**RE: Volcano Cliffs Subdivision Lot 1, Block 8, Unit 18
6512 Papagayo Rd. NW
Grading and Drainage Plan
Engineers Stamp Date 1/30/17 (D10D003O1)**

GRADING AND DRAINAGE PLAN
LOT 1, BLOCK 8, UNIT 18, VCS
ADDRESS: 6512 Papagayo Rd NW

GRADING & DRAINAGE PLAN
6512 Papagayo Road, NW
LOT 1, BLOCK 8, UNIT 18 VCS
PAD CERTIFICATION Sheet 2 of 2

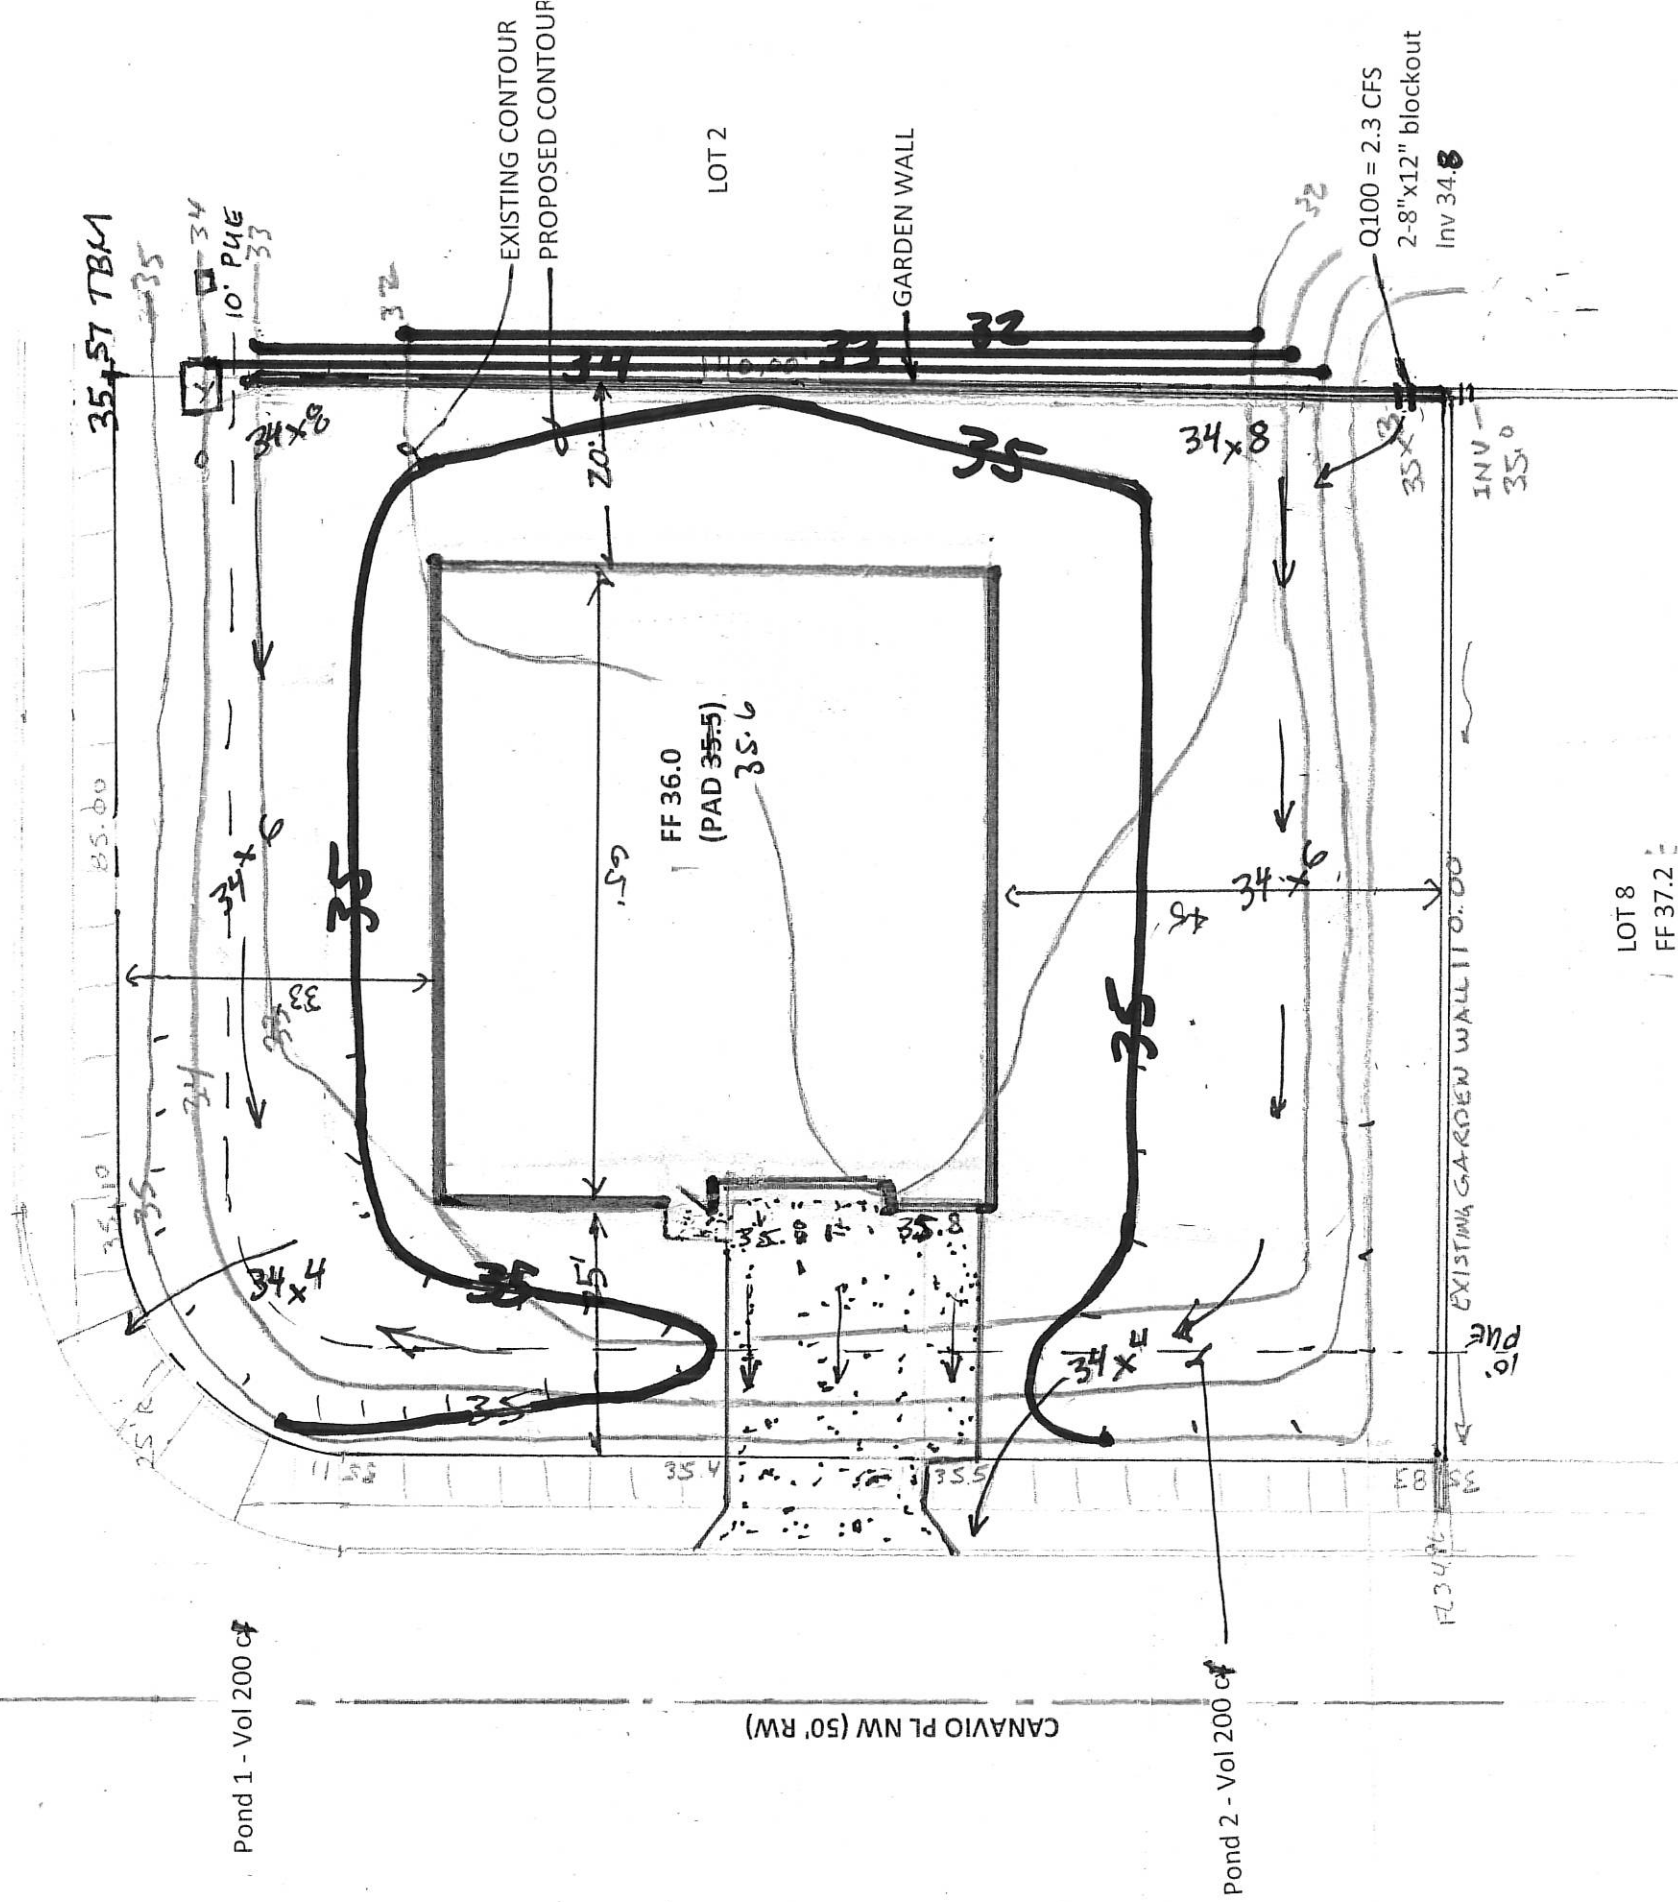
- Provide a note stating that future garden walls require a separate permit and this plan should be used for their placement.
- Also state that future garden walls require an opening 3" above grade in the SW corner.
- Provide a statement that a pad certification is required before a building permit is given.

- Note:
1. Future garden walls require a separate permit and this plan should be used for their placement.
 2. Future garden walls require an opening 3" above grade in the SW corner.
 3. A pad certification is required before a building permit is given.
